Subject: **Response to Portion of NRC Request for Additional  
Information Letter No. 124 Related to ESBWR Design  
Certification Application – Turbine Main Steam System –  
RAI Number 10.2-27**

**Response to Portion of NRC Request for  
Additional Information Letter No. 124  
Related to ESBWR Design Certification Application  
Turbine Main Steam System  
RAI Number 10.2-27**

### **NRC RAI 10.2-27**

Figure 3.2-1. Quality Group and Seismic Category Classification Applicable to Power Conversion System

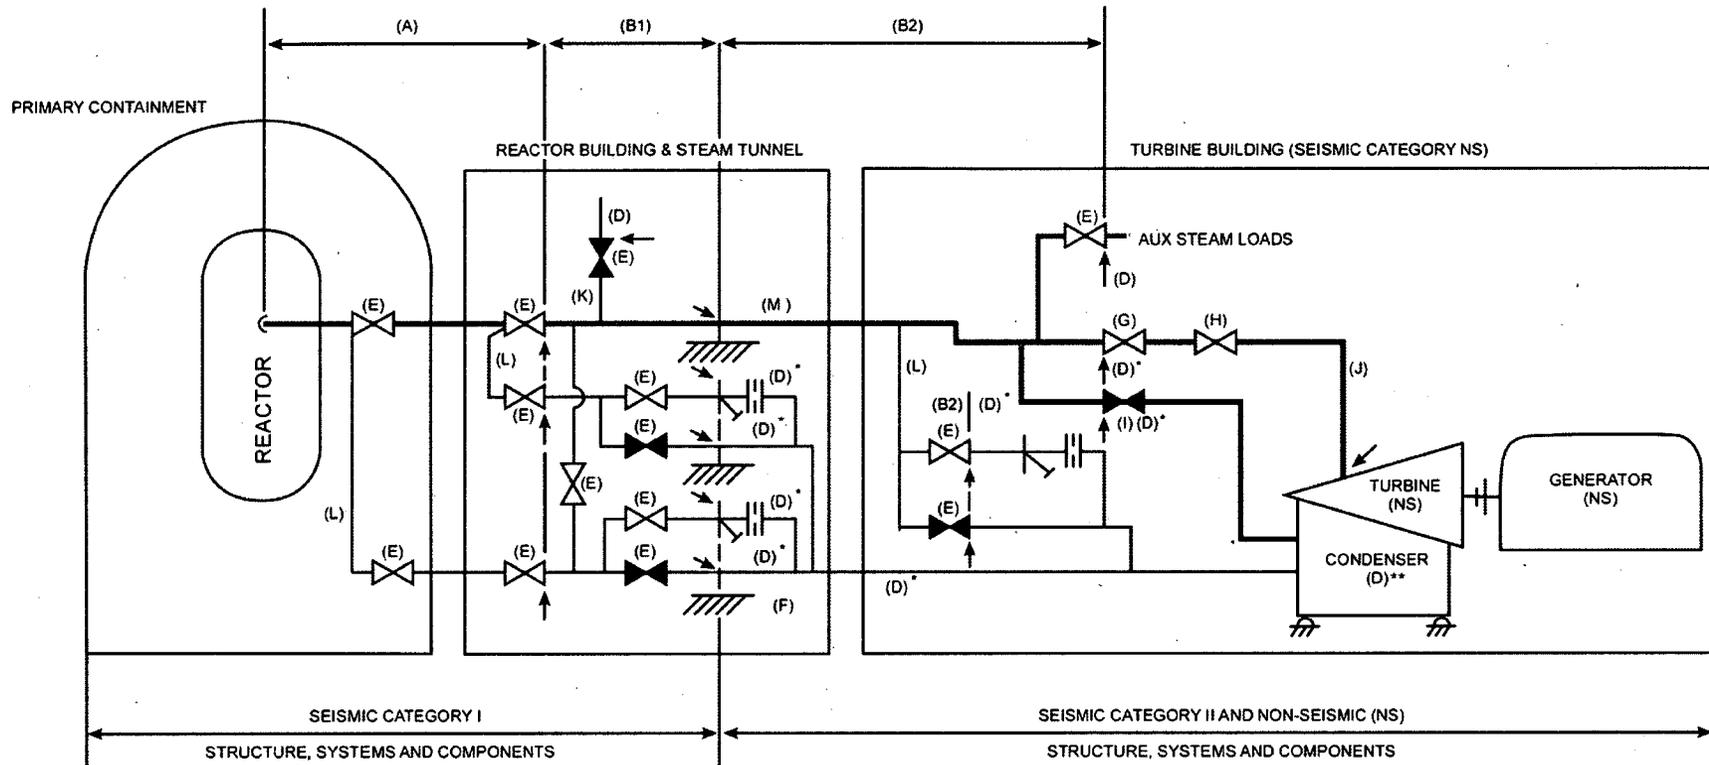
*DCD Tier 2, Section 10.2.1.1, Revision 3, states that the main steam stop valve and steam line from the stop valve to the turbine are analyzed to maintain structural integrity following a safe shutdown earthquake (SSE). This statement was deleted in Revision 4. However, this is inconsistent with footnote (9) in Table 3.2-1. Please clarify the seismic design of the turbine stop valves.*

DCD Tier 2, Figure 3.2-1 will be revised in Revision 5 as noted on the attached markup page.

The main steam lines from the turbine stop valves (including the stop valves and the control valves) to the turbine nozzles are classified as Quality Group D components in accordance with Regulatory Guide 1.26, Regulatory Position C.1(c) and Branch Technical Position 3-1. They are not required to be safety-related or Seismic Category I. However, they are designed to maintain structural integrity under safe shutdown earthquake (SSE) loading conditions, in accordance with Regulatory Guide 1.29, Regulatory Position C.1(e) and SECY 93-087, Section II.E.

DCD Tier 2, Revision 4, Subsection 10.2.2.1, states "TG system components, equipment, and piping are classified as discussed in Section 3.2." Further clarification of the seismic design requirements will be included in DCD Revision 5. This will include clarification of footnote 9 on Table 3.2-1.

LEGEND:		
A.	QUALITY GROUP A	
B 1.	QUALITY GROUP B	
B 2.	QUALITY GROUP B, SEISMIC CATEGORY II	
D.	QUALITY GROUP D	
E.	ISOLATION VALVE	
F.	SEISMIC INTERFACE RESTRAINT	
G.	TURBINE STOP VALVE	
H.	TURBINE CONTROL VALVE	
I.	TURBINE BYPASS VALVE	
J.	MAIN STEAM LEAD	
K.	INSTRUMENT BRANCH LINE	
L.	DRAIN LINE	
M.	STEAM LINE	
NS	NON-SEISMIC	
↙	CLASSIFICATION CHANGE	
		* ANALYZED TO DEMONSTRATE STRUCTURAL INTEGRITY UNDER SSE LOADING CONDITIONS FOR MSIV LEAKAGE PATH
		** CONDENSER SUPPORTS AND ANCHORS ARE DESIGNED TO MAINTAIN CONDENSER INTEGRITY FOLLOWING SSE FOR MSIV LEAKAGE HOLDUP VOLUME.
